SI B51 14 18
Body Equipment

RATTLE NOISE FROM DOOR WHEN CLOSING

F22 (2 Series Coupe)	F23 (2 Series Convertible)	F87 (M2)	
----------------------	----------------------------	----------	--

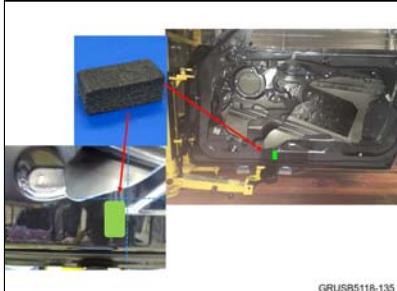
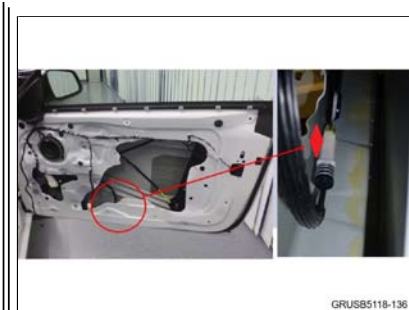
The window regulator drive cable is resting against the inside of the door, and can rattle or buzz when the door is closed.

Note: The photos to the left show the general location for installation of the sound insulation foam. The foam will be installed **inside** the door cavity, between the regulator cable and door.

Install sound insulation foam between the regulator drive cable and the inside of the door.
